Re: Indian Point Unit 3
Docket No. 50-286
NL-04-155

Subject: **Supporting Information for License Amendment Request
Regarding Indian Point 3 Stretch Power Uprate (TAC MC 3552)**

Graph 1 for NL-04-095-GIP-11

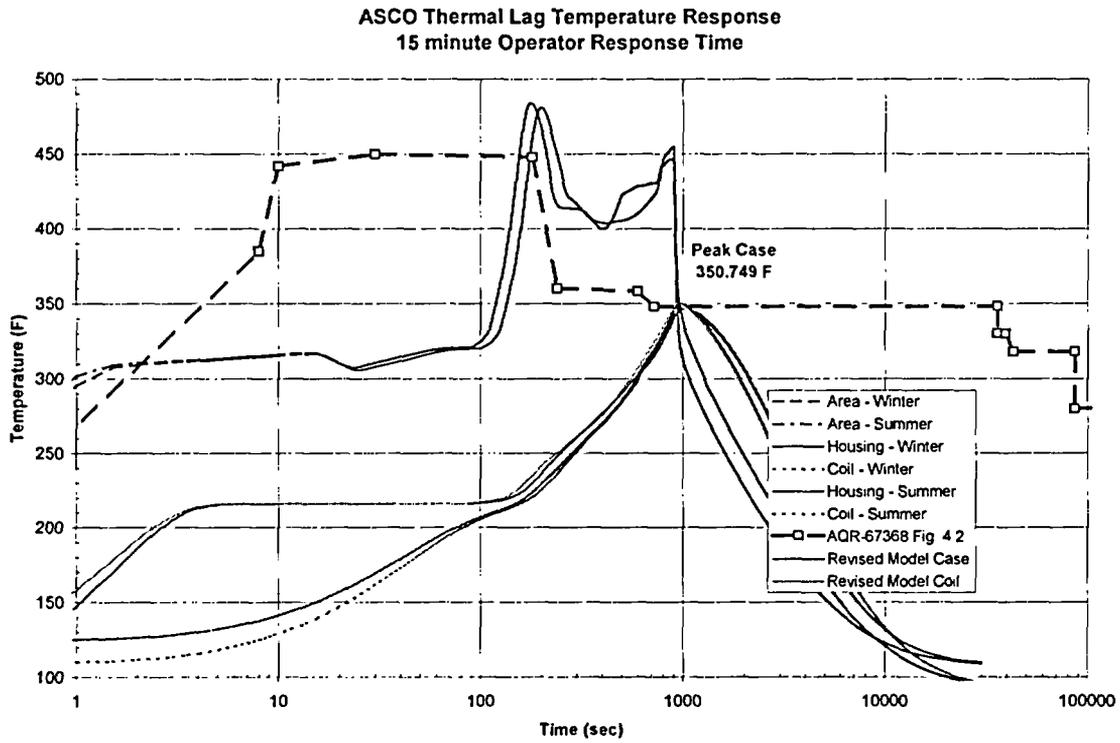
Section 10.8.4, "SPU Equipment Qualification Evaluation," states that accident temperatures outside containment in the steam and feedline penetration area have been reanalyzed and result in higher temperatures, and that all equipment outside containment required for accident response have been justified as qualified.

1. ASCO solenoid valves are qualified for both the 10-minute and the 15-minute operator response time. The peak temperature of the 15-minute operator response time is 350.749°F. The ASCO test report (Reference 1) demonstrates that the ASCO solenoid valves have been tested to temperatures enveloping this peak temperature.

2. Buchanan terminal blocks are qualified for both the 10-minute and the 15-minute operator response time because the qualification test envelopes the accident profile. The maximum thermal lag temperature of the terminal blocks is 322.3°F. The qualification test peaks at 346°F.

3. The Westinghouse terminal blocks are not qualified for the 322.3°F temperature (15 minute response), but are qualified for the 10-minute operator response time with the peak thermal lag temperature of 279°F compared to the qualification test temperature of 295°F (Reference 2).

4. GE Flamenol PVC cable is shown to be qualified for the 10-minute operator response time. The peak temperature of the 15-minute operator response time is 362.676°F (1.4 SF break in winter with 15-minute operator response). The peak test temperature is 370°F. The time over the qualification curve can be shown to reduce the time of the qualification temp of 350°F long term by only 748 seconds. The impact is an 8% reduction of thermal life at 350°F but no impact on the overall transient being enveloped by the qualification test. Therefore the GE Cable is considered also qualified for the 15-minute operator response time.

5. The Rockbestos Firewall III cable is qualified to 674°F (Reference 3).
6. Conax conduit seals are qualified for both the 10-minute operator response time and the 15-minute operator response time. The peak thermal lag temperature of the Conax is 329.876°F (1.4 SF break in winter with 15 minute operator response time). The qualification test peaks at 380°.

7. Namco limit switches are qualified for the 10-minute operator response time. The peak temperature of the 15 minute operator response time of 335.313°F (1.4 SF break in winter with 15 minute operator response) exceeds the existing qualification test of 315°F. However, the following qualification test reports yield higher temperatures: QTR 157, Rev 1 peaks at 364°F and QTR 155 peaks at 341°F. Also, the length of time that the Namco exceeds the test temperature of 315°F is 1777 seconds and results conservatively in reducing the thermal life at 315°F slightly (4%) which does not affect the test enveloping the accident temperature. Therefore, the Namco limit switches are considered also qualified for the 15-minute operator response time.

Summary: All of the equipment, except the Westinghouse terminal blocks, is qualified for accident conditions for the longer 15-minute operator response time. All of the equipment is qualified for the 10-minute operator response time.

Figure 1 - Peak Cladding Temperatures

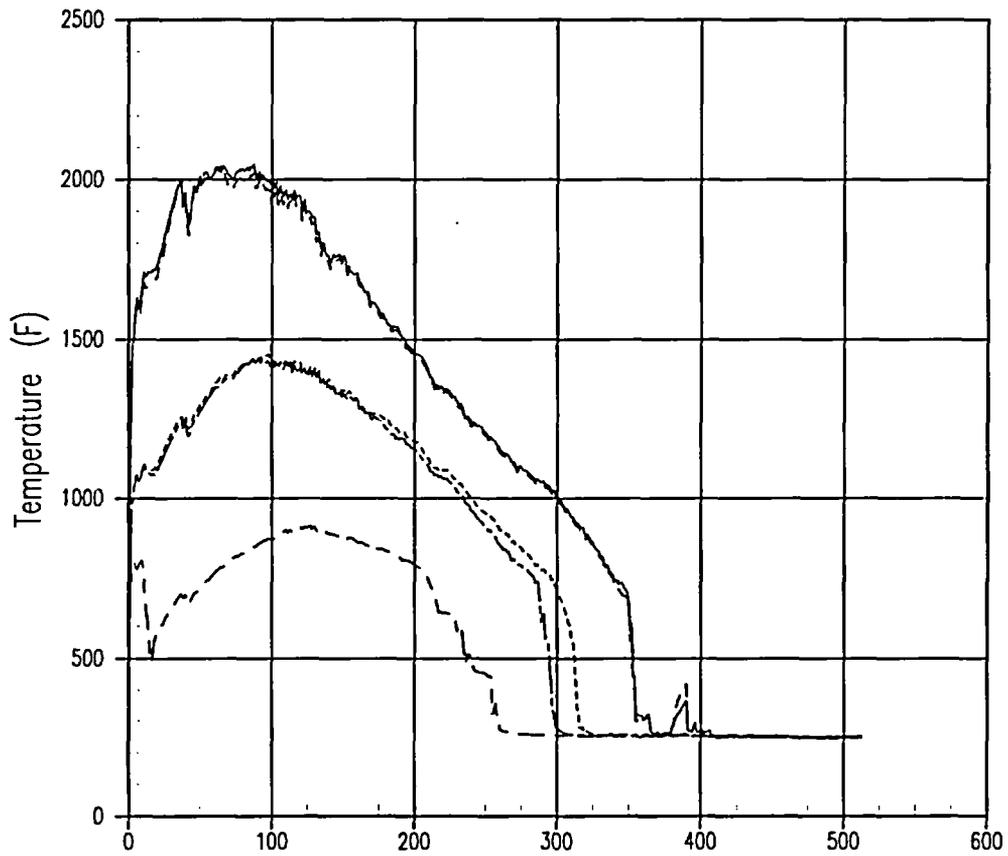
Provide the LBLOCA analysis results (tables and graphs, as appropriate) to the time that stable and sustained quench is established.

Figure 1 shows the peak cladding temperatures for the five rods modeled in WCOBRA/TRAC. This figure indicates that quench occurs at about 260 seconds for the low power rod (Rod 5), about 300-320 seconds for the core average rods (Rod 3 and 4), and about 400 seconds for the hot rod (Rod 1) and hot assembly average rod (Rod 2). Once quench is predicted to occur, the rod temperatures remain steady and slightly above the fluid saturation temperature for the remainder of the simulation.
